# DOCUMENT CHANGE REQUEST

<b>Doc. No.</b> (6) 4006/014	<b>Status</b> (7) Issue 4, Jul-05	<b>Title</b> (8) THERMISTORS (THERMALLY SENSITIVE RESISTORS), NCT, RANGE 2 000 TO 100 000 OHMS AT + 25°C WITH A TEMPERATURE RANGE OF - 60 TO + 160 °C	<b>Other documents affected</b> (10)  NONE
<b>Paragraph(s) and page(s) affected</b> (9) Page 8: FIGURE 2 – PHYSICAL DIMENSIONS / NOTE 1

## PROPOSED WORDING OF CHANGE FOR FIGURE 2:

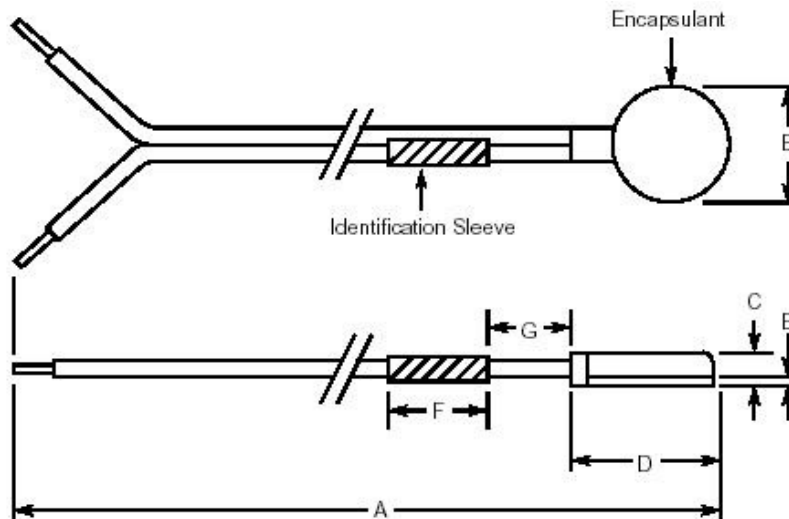
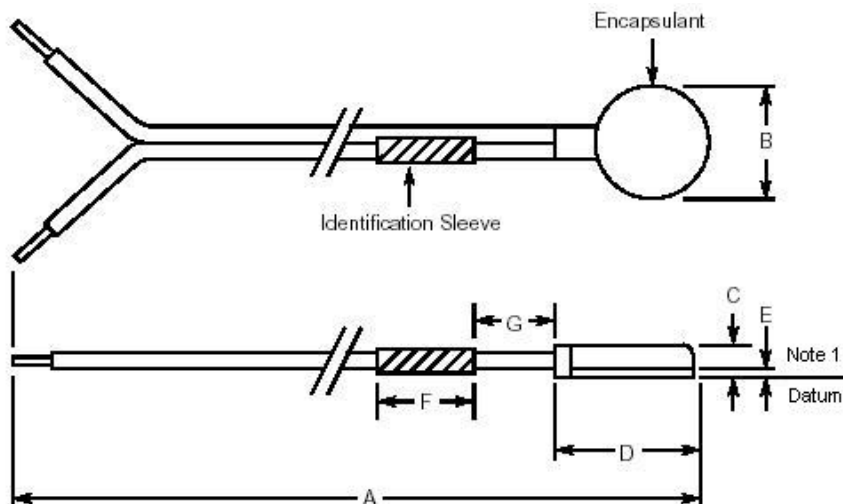
### CHANGE FIGURE 2 FROM:

### CHANGE FIGURE 2 TO:

Existing ESCC Detail specification 4006/014 does not adequately specify the Flatness of the Component. Components with inadequate flatness will cause problems when they are assembled by customers.
